**Environmental  
Impact  
Statement**

**Prudhoe Bay Oil Field  
Waterflood  
Project  
Prudhoe Bay, Alaska**

**Volume 3 of 3  
Public Comment  
and  
Responses**

**Corrections  
and  
Additions  
to  
Volume 2**

**PROPOSED OUTFALL PIPELINES  
LOCATION PLAN**

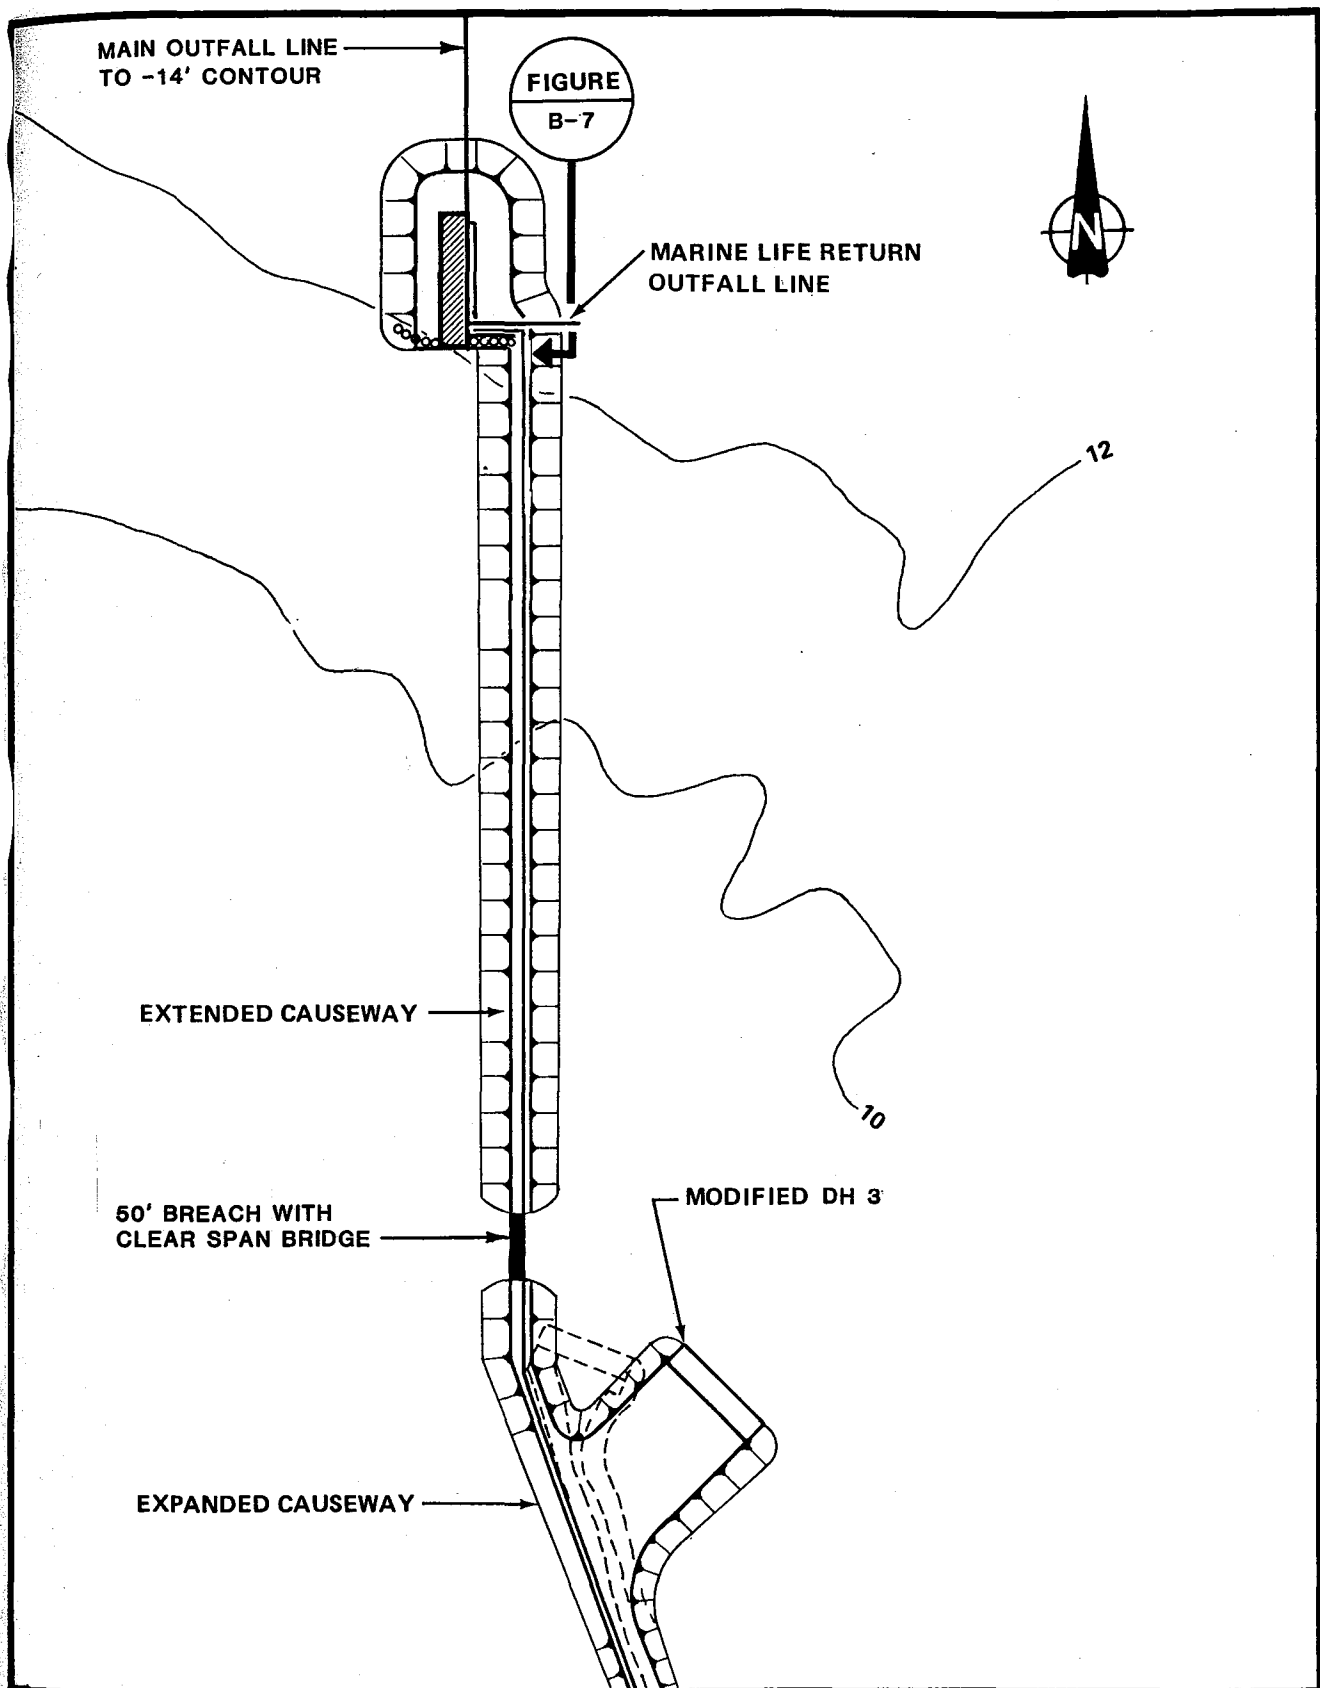
2. The EIS should contain a very direct discussion stating that the treatment plant outfall location must be north of the facility at approximately the 14 foot depth contour in order to meet the NPDES permit requirements and the State water quality standards.

The first sentence of page 2-77, last paragraph, should be worded to once again emphasize NPDES requirements: "Locating the outfall line offshore of the treating plant would virtually eliminate chances of recycling and will be required for the applicant to comply with State water quality standards". The following sentence regarding effects on biota is misleading and could be replaced with: "The modeling prepared for this outfall location (Mangarell 1980) provides a dilution factor of 50 within the ADEC approved mixing zone".

- 16 Main Outfall Line: The outfall line should be redesigned so that the diffuser is located at least 1000 feet north of the proposed plant site in water depths of at least 14 feet. This realignment will allow greater dilution and dispersion of wastewater and eliminate recycling of wastewater in the winter, thus ensuring that water quality standards for sediments and chlorine are maintained.

- 51 2-20 Figure 2.5-4
- The Department of Environmental Conservation will be requiring the northward outfall location through the NPDES permit or in its 401 certification. The westward proposal (as diagrammed) is unacceptable. The Final Environmental Impact Statement (FEIS) should be revised accordingly.

2. The applicant has modified the proposed project to include the treatment plant outfall at the 4.2-m (14-ft) contour. Text is changed accordingly and includes a dilution factor of 50.

7. The applicant's revised project includes the outfall north of the treating plant at the 14-foot contour. This location will meet Alaska water quality standards. An inshore location, now considered an alternative, will likely violate the State standards. Text has been revised accordingly.

PROPOSED MARINE LIFE RETURN OUTFALL PIPELINE  
&  
PROPOSED MAIN OUTFALL PIPELINE

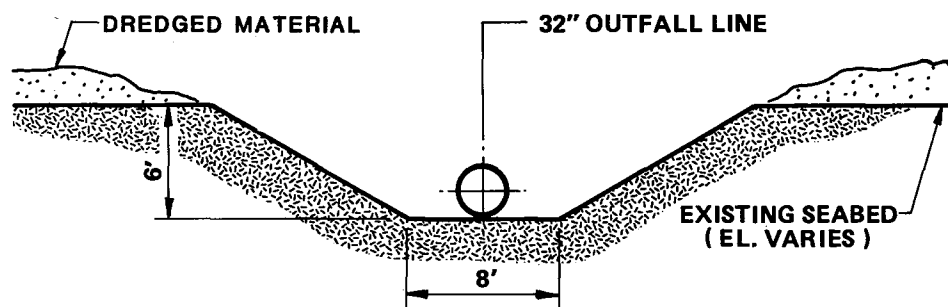
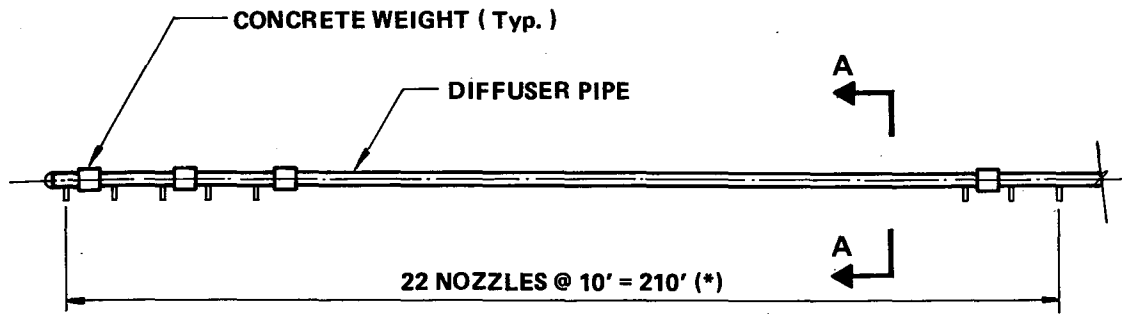
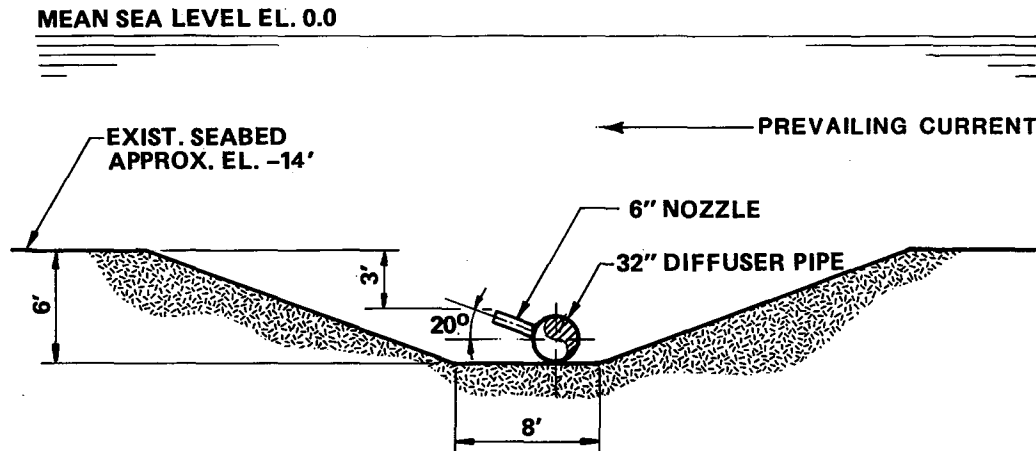
12. Figure 2.5-17 is incomplete. It does not show the probable locations for the filter backwash outfall or the marine life return line. The probable locations are identified in the text.

12. Agree. The marine life return line and outfall locations are now included on the figure.
